National Highways Planning Response (NHPR 26-09)
Formal Recommendation to an Application for Planning Permission

Council's Reference: AWDM/0460/26

Location: 120 Upper Brighton Road, Worthing, West Sussex BN14 9JB

Proposal: Proposed extension to width of vehicular access

(Source: DMRB)

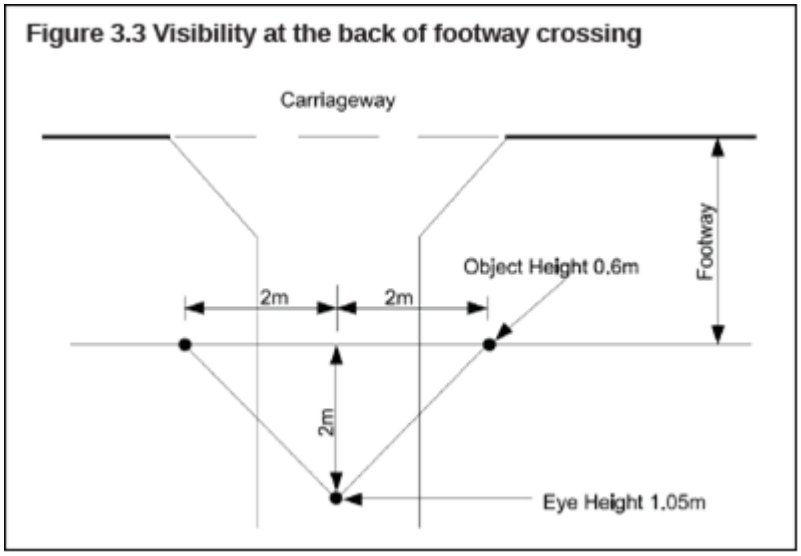
As the A27 is part of the SRN, visibility splays measured from the edge of carriageway must be in accordance with the standards in the Design Manual for Roads and Bridges. **The applicant will need to provide visibility splays which are required to be shown in full as per DMRB CD 123 to ensure that the visibility splays are clear of obstructions.**

Clause 3.3 of DMRB CD 123 states that "where a direct access crosses a footway, a visibility splay shall be provided in accordance with Figure 3.3". Figure 3.3 is shown

below. A clear visibility splay measured from a point 2m from the rear of the footway, in each direction for 2m shall be provided.
